PUBLICATION INDEX FOR SGS 2-32

BULLETIN NO. SA-001.6*

SUBJECT: ONE-TIME INSPECTION OF TOW RELEASE ASSEMBLY; DAILY INSPECTION OF TOW RELEASE ASSEMBLY; PILOT'S PREFLIGHT INSPECTION OF TOW RELEASE ASSEMBLY; 100 HOUR/ANNUAL INSPECTION OF TOW RELEASE ASSEMBLY.

OVERVIEW: The .5 revision is the same as the .4 revision except changes to Figures 1, 3, & 4. Figure 1 has changed to add View D to show improper engagement. Figure 3 has been changed to show proper release arm cutout. Figure 4 has been changed to show proper readings for the C.G. hook install.

FIGURE 1 – ENGAGEMENT OF TOW HOOK INTO RELEASE ARM

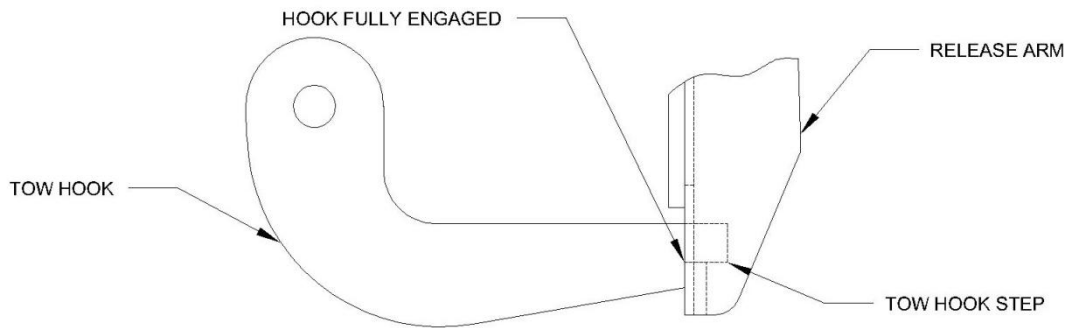
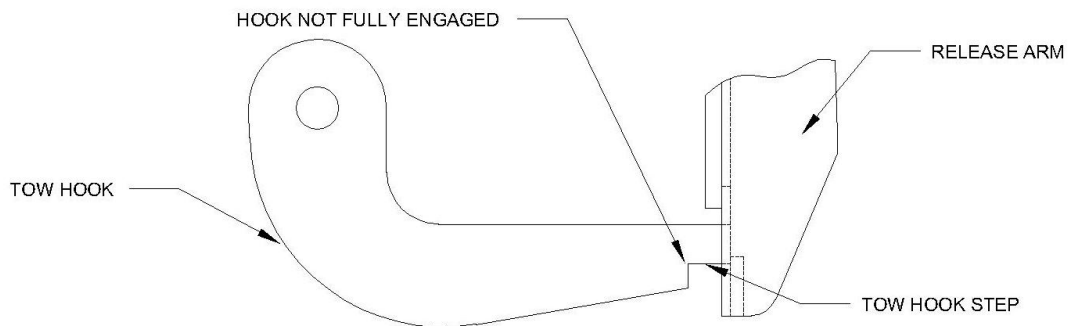
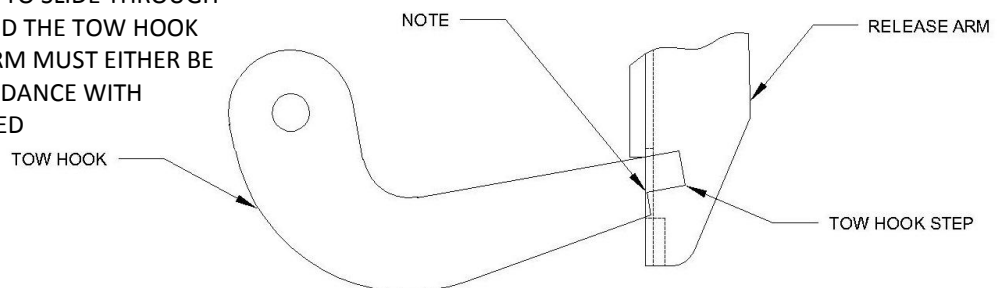
- Figure 1 shows the proper attachment of the tow hook into the release arm. Note that the step of the tow hook should seat against the release arm. The tow hook step must fully engage the release arm to allow the release assembly to function properly. The tow hook must not be allowed to extend through the release arm beyond the step on the hook as shown in Figure 1, View C.

IF TOW HOOK IS ABLE TO SLIDE THROUGH RELEASE ARM, BEYOND THE TOW HOOK STEP, THE RELEASE ARM MUST EITHER BE REWORKED IN ACCORDANCE WITH FIGURE 3, OR REPLACED

- d. If tow hook dimensions are not within limits specified in Figure 2, either rework the tow hook to obtain dimensions (as specified in Figure 2) or replace it with a new or serviceable, used tow hook
- e. Engage tow hook into release arm. Ensure that the tow hook properly engages as shown in Figure 1, View A.
- f. If tow hook is unable to completely engage (shown by Figure 1, View B) shorten the rubber bumper stop between the release knob and the instrument panel to allow the release assembly to close further.

- g. If tow hook is able to travel too far inboard as shown in Figure 1, View C, disengage tow hook from release arm and measure the length of the release arm slot
- h. If dimension is less than 0.66 inch, rework release arm by welding on 1B-217-19 slug at location shown in Figure 3. (Release arm may be replaced as an alternate to welding on slug)
- i. If length of release arm slot is greater than 0.66 inch, replace release arm.
- j. Perform a thorough inspection of the tow hook installation in accordance with the 100 hour inspection requirements listed in Table 2 of this bulletin.
- k. Repair or replace unserviceable component(s), as required
- l. Record compliance with Part I of this Service Bulletin in Aircraft Log Book.

FIGURE 2 – TOW HOOK INSPECTION AND REWORK (SHEET 1 OF 2)

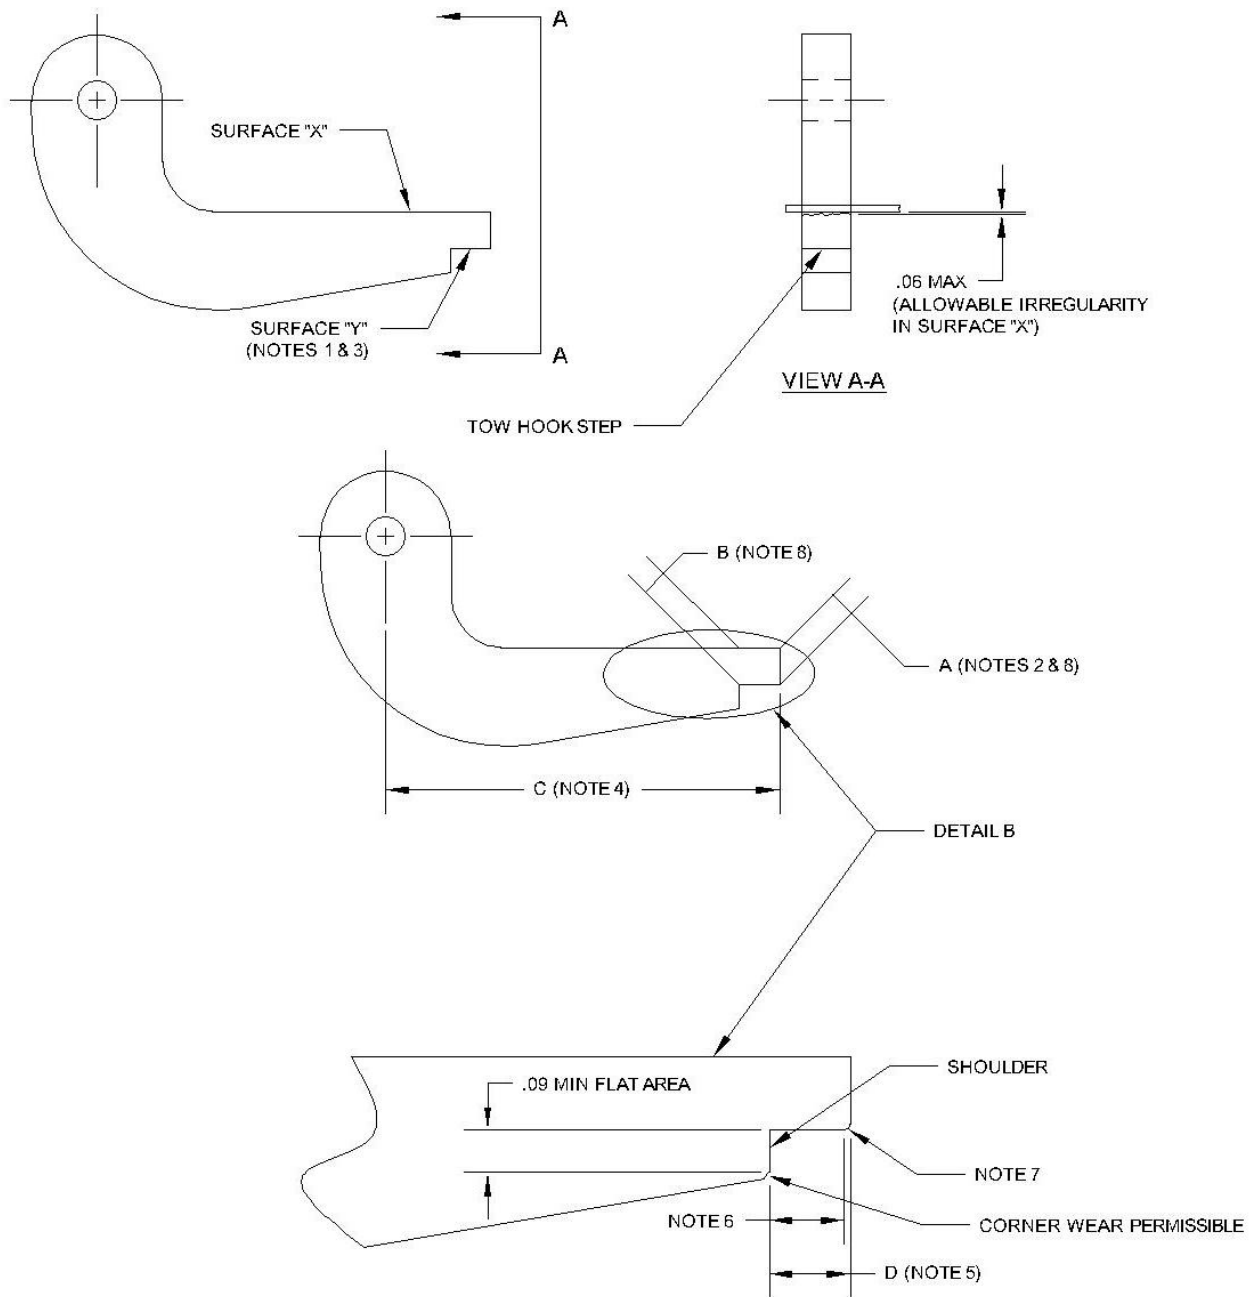
- Proper engagement of the tow hook into the release arm is shown in Figure 1, View A, and Figure 4. Excessive wear of the tow hook step could result in improper engagement. Figure 2 of this bulletin provides inspection data and wear limits for the tow hook. Tow hooks which do not meet the specified limits must either be reworked to obtain dimensions (as specified in Figure 2) or replaced.
 - If tow hooks is able to slide into the release arm, beyond the tow hook step, as shown by Figure 1, View C, the release arm must either be reworked with a slug as specified in Figure 3, or replaced.
- c. Inspect tow hook for wear in accordance with Figure 2 of this bulletin.

1. IF WEAR OCCURS ON SURFACE "Y" IT MUST BE POLISHED FLAT WITHIN TOLERANCES PROVIDED IN FIGURE 2 (SHEET 1). IF THE HOOK CANNOT MEET THESE REQUIRED DIMENSIONS IT MUST BE REPLACED. UNDER NO CONDITIONS SHOULD SURFACE "X" BE POLISHED OR MACHINED TO CHANGE ITS ANGLE.

2. DIMENSION "A" ON STD 10232-001 HOOK SHALL BE .21 INCHES MIN. & .28 INCHES MAX. DIMENSION "A" ON STD 1A218-1A, STD 1B221-3, & R-200-9A HOOKS SHALL BE .25 INCHES MIN. & .31 INCHES MAX.

3. SURFACE "Y" MUST REMAIN FLAT, SMOOTH, AND WITHIN TOLERANCES SHOWN ON SHEET 1. (SEE ILLUSTRATION).
4. DIMENSION "C" ON STD 10232-001 HOOK SHALL BE $2.06 \pm .03$ INCHES. DIMENSION "C" ON STD 1A218-1A, STD 1B221-3, & R-200-9A SHALL BE $3.00 \pm .03$ INCHES.

5. DIMENSION "D" ON STD 10232-001 HOOK SHALL BE $.25 \pm .03$ INCHES. DIMENSION "D" ON STD 1A218-1A, STD 1B221-3, & R-200-9A SHALL BE $.31 \pm .03$ INCHES.

6. HOOK MUST REMAIN FLAT IN THIS AREA FOR A MIN. OF .21 INCHES FROM SHOULDER OF HOOK.
7. WEAR OUTSIDE OF THE .21 MIN. FLAT AREA IS PERMISSABLE.
8. DIMENSION "B" MUST BE EQUAL TO DIMENSION "A", OR LESS THAN DIMENSION "A" BY NO MORE THAN .015 INCHES AND CANNOT BE GREATER THAN DIMENSION "A".

FIGURE 3 - REWORK OF RELEASE ARM

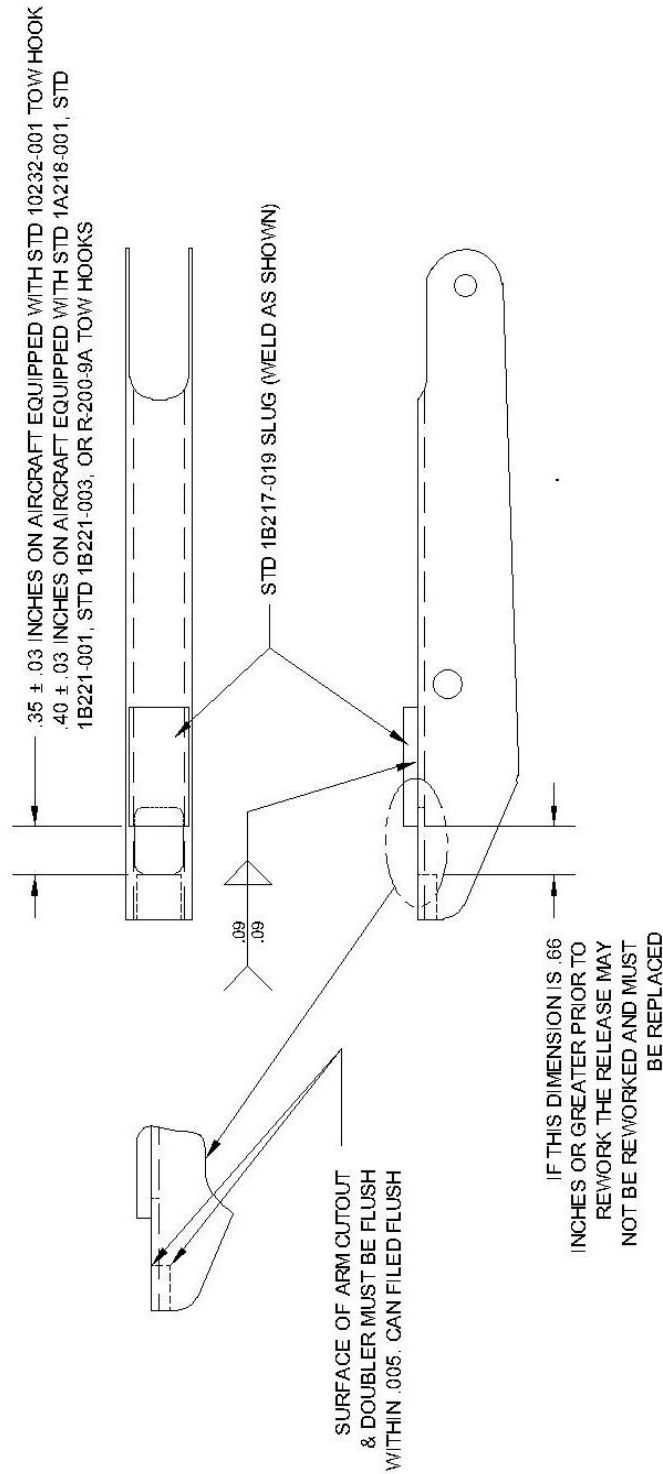
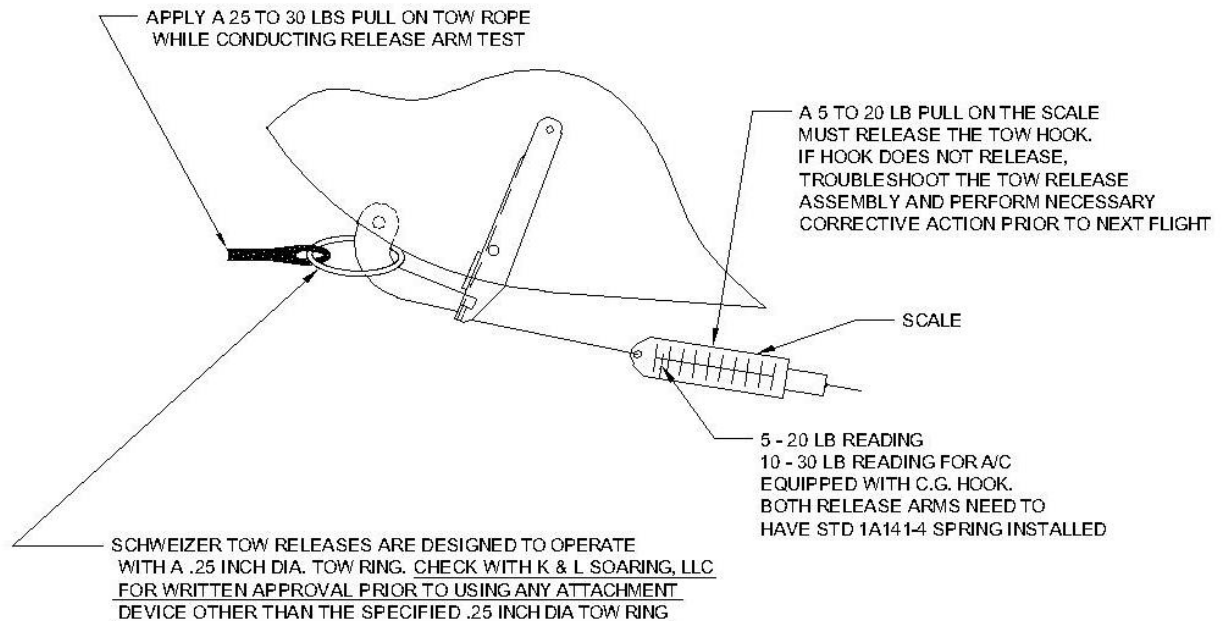
NOTE: STD 1B217-019 SLUG IS AVAILABLE FROM K & L SOARING, LLC
0.125 X 0.5 X 1.0 4130N STEEL

NOTE: ALL TOW RELEASE ARMS MUST BE REWORKED AS SHOWN ABOVE OR REPLACED WITH THE PROPER SUPERSEDING ARM AS SPECIFIED IN TABLE 1

FIGURE 4 - PULL TEST OF TOW RELEASE ASSEMBLY

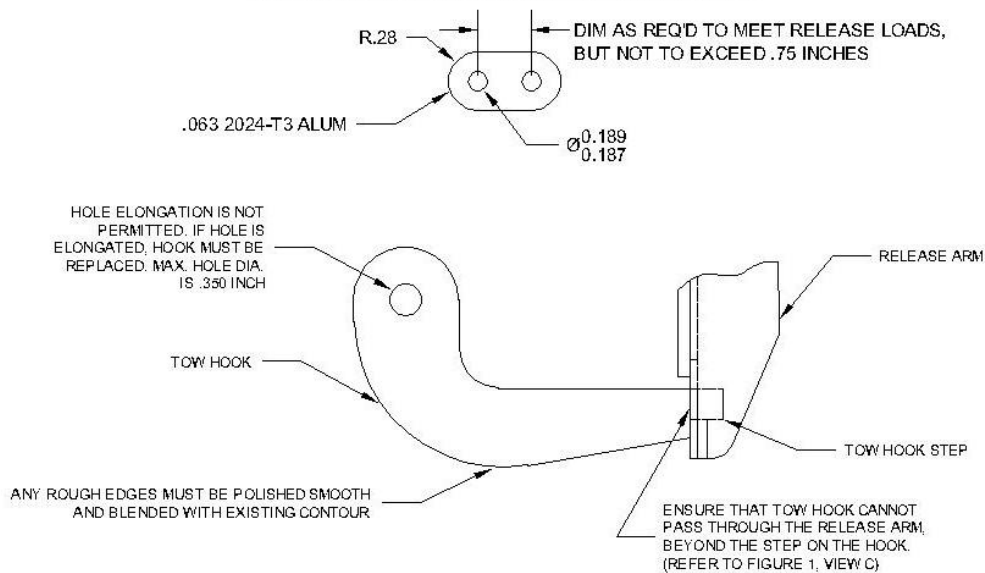
NOTE: IF RELEASE LOADS ARE TOO HIGH WITH C.G. SYSTEM IT IS PERMISSIBLE TO ADD A LINK TO SHORTEN STD 1A141-2 SPRING. LINK SHOULD BE MADE AS SHOWN BELOW. IF REQUIRED THEY SHOULD BE ADDED TO BOTH RELEASE ARMS TO BALANCE BOTH RELEASE SPRINGS
